An  
Bord  
Pleanála

### Inspector's Report ABP-313825-22

#### Strategic Housing Development

7 year permission for 344 no. residential units (130 no. houses, 214 no. apartments), creche and associated site works

Figure 12.1 Design Concept for KDA 2 Ballyoulster

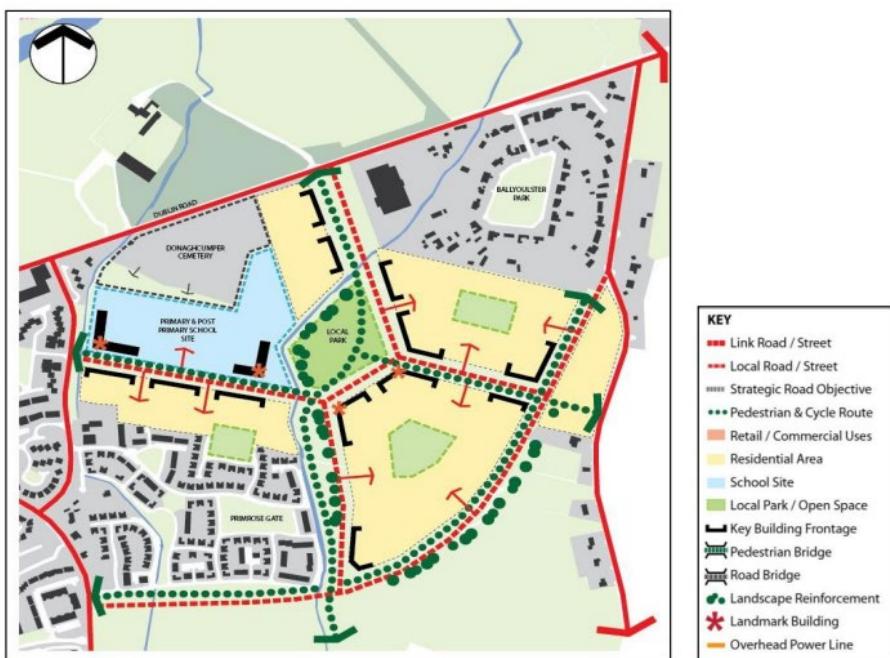
10.4.2. The issue of the Design Concept for the site as established by the KDA2 - Ballyoulster Figure 12.1 of the LAP is addressed in the applicants Material Contravention Statement. In this regard, it is argued by the applicant and I would agree that KDA2 Figure 12.1 is a indicative design concept for the site only. In any case, I refer the Board again to the fact that the LAP has expired and in this context criteria as set for KDA2-Ballyoulster have no statutory basis. In the absence of the LAP the Kildare Conty Development Plan is the operative Plan for the area.

10.10.6. As set out above the Celbridge LAP expired on 16<sup>th</sup> August 2023. Notwithstanding with respect to Figure 12.1 of the LAP, section 12.2 Key Development Areas -
